Code Technology Committee

Area of Study – NIST World Trade Center Recommendations

2007/2008 Cycle
Code changes related to the CTC area of study noted above

FILE 1 OF 2

FIGURE 1614.4
LONGITUDINAL, PERIMETER, TRANSVERSE AND VERTICAL TIES

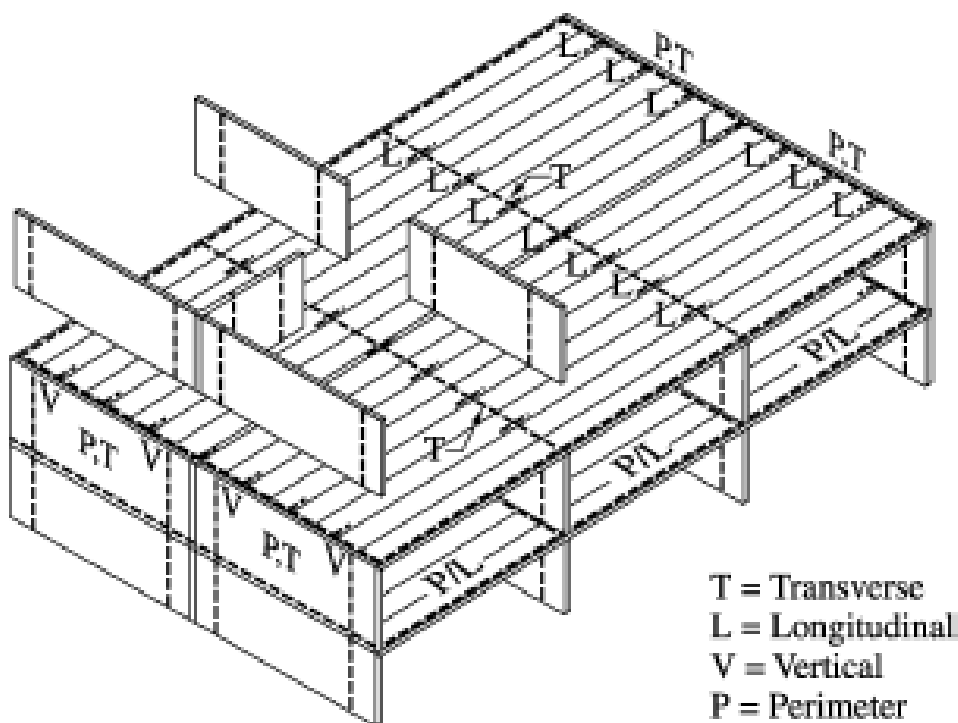
1614.4 Bearing wall structures. Bearing wall structures shall have vertical ties in all load bearing walls and longitudinal ties, transverse ties, and perimeter ties at each floor level in accordance with this section and as shown in Figure 1614.4.
